Moser Pass
Case File: LU 2020-020 PUD/SUB
Final Development Plan

To: Planning Commission

Proposal: On March 7, 2023, City Council adopted Ordinance 2023-001 approving a Planned Unit Development (PUD) and Subdivision to be known as Moser Pass PUD (Case File LU 2022-020 SUB/PUD). The applicant now proposes a Final Development Plan and Final Subdivision Plat for the PUD. Like the approved project, the Final Development/Subdivision Plat proposes a 30-lot residential subdivision and PUD with a community park on a 12.36-acre property. The property is zoned Very Low Density Residential (VLDR) and is in the Southeast Sherwood Master Plan area. The applicant is proposing a minimum lot size of 10,000 SF and overall density of approximately 3.06-units per acre.

- 20' X 20' CLEAR VISION AREA

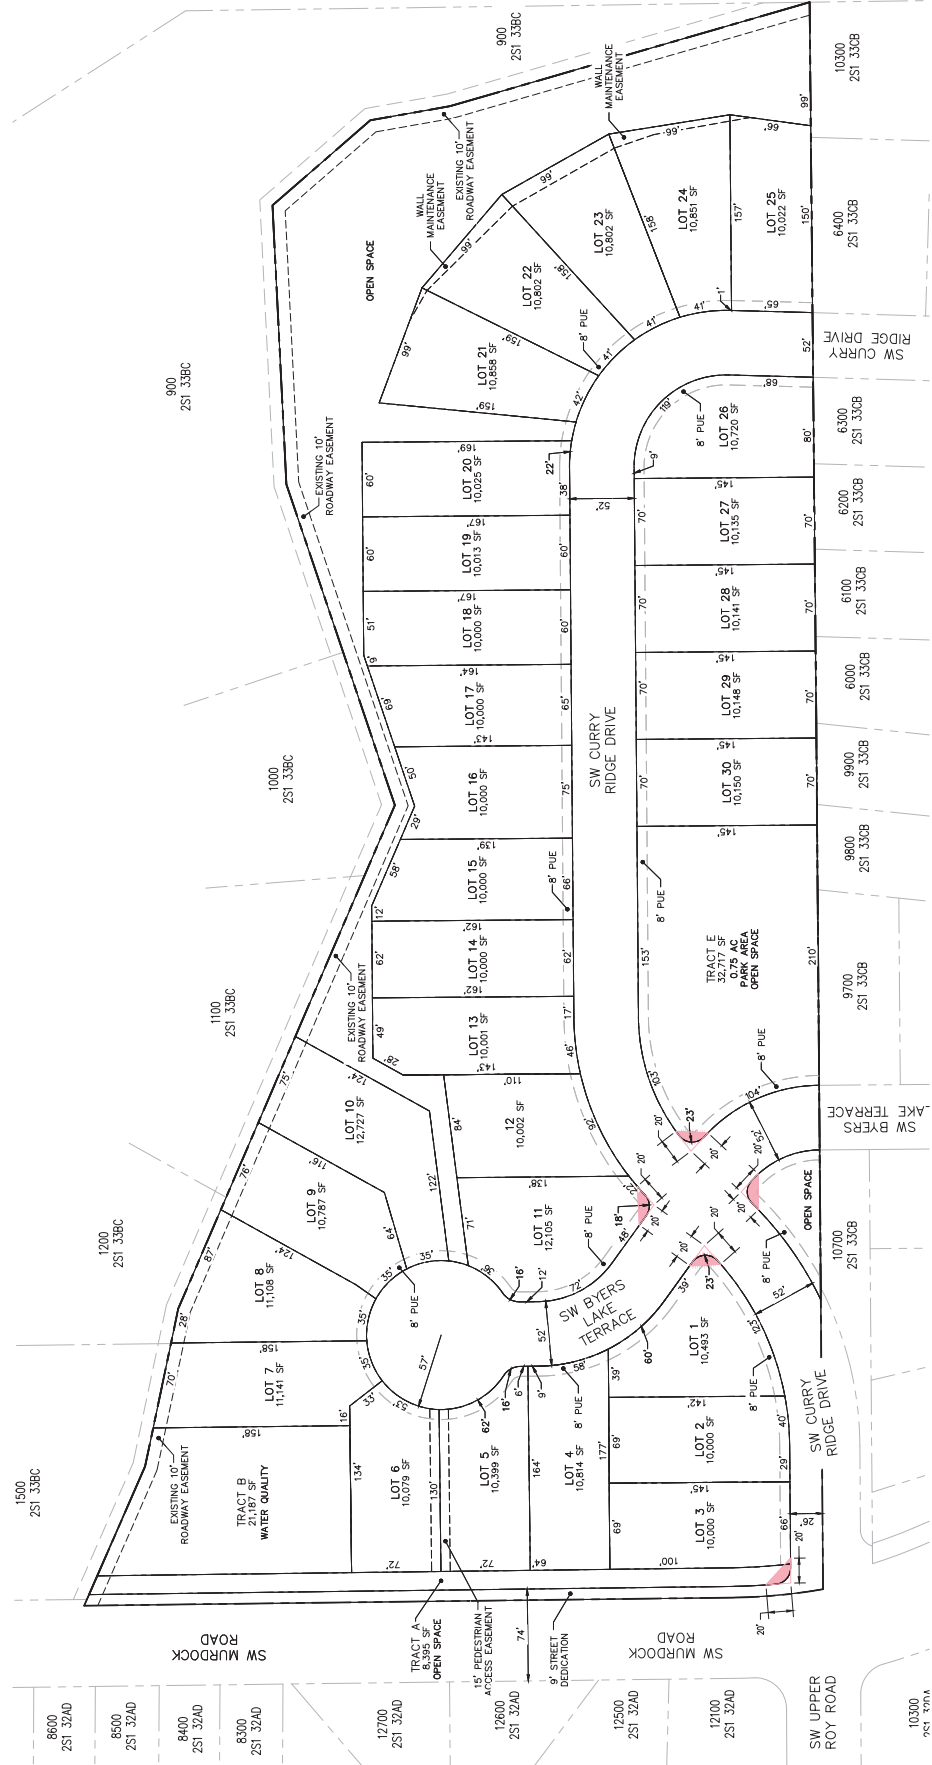
3. Prior to Final Plat Approval, show a clear vision area on the corners of each street intersection in accordance with SZCDC § 16.58.010 Clear Vision Areas.

Exhibit E shows the clear vision areas but needs to include dimensions with labels. Please revise Exhibit E that include the dimensional requirements for the clear vision areas.

Applicant Response: Exhibit E has been updated to include dimensions for each of the clear vision triangles. The standards of SZCDC 16.58.010 are shown to be met.
